## PICkit 3 Operation at Low Voltage - Modification

Figure 1

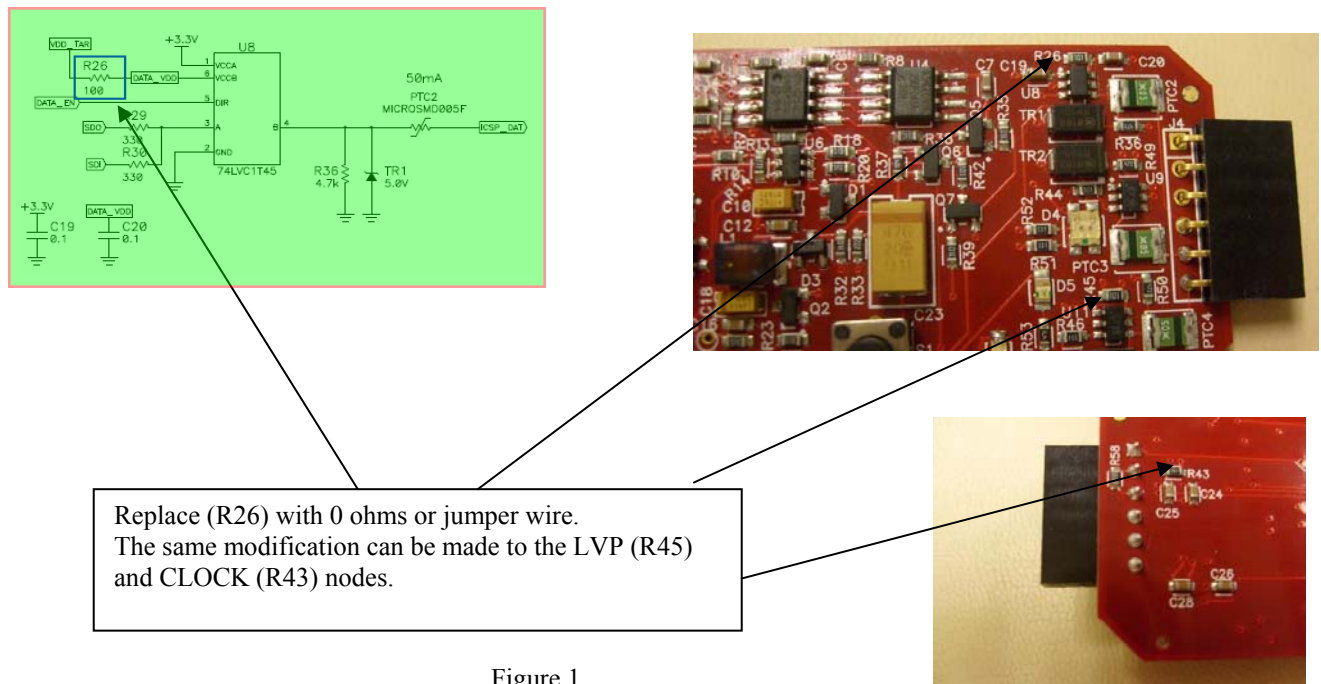
**Symptom:** PICkit 3, Assembly #10-00424-R4 or below may not be able to detect a device at the minimum VDD voltage operation of some devices. This problem manifests itself when the source of power comes from the PICkit 3. The problem is the output clock and data buffers are current limited and due to the coarse regulation of the internal VDD power supply switcher, the voltage may get lower than the minimum threshold required for the device to operate. The symptom is often unable to attain the device ID or conduct programming and debugging operations.

**Problem:** The PICkit 3 clock and data buffers have a series resistor in the VDD path to limit current. During an ICSP operation, the output voltage of the buffers may decay sufficiently when operating at low voltage to cross the minimum threshold of operation of the device.

**Solution:** There are several workarounds. One solution is to simply use external target power where the voltage regulation of the external power supply is 1% or better of the desired level and ensure the current supplied is at least 50ma. Another solution is to simply increase the voltage in MPLAB IDE to compensate for the voltage drop across the resistor. The last and more permanent solution is to change the resistors (R26, R43, and R45) in the CLOCK, DATA, and LVP buffer path from 100 ohms to 0 ohms so the voltage drop is eliminated. See figure 1 for rework details.
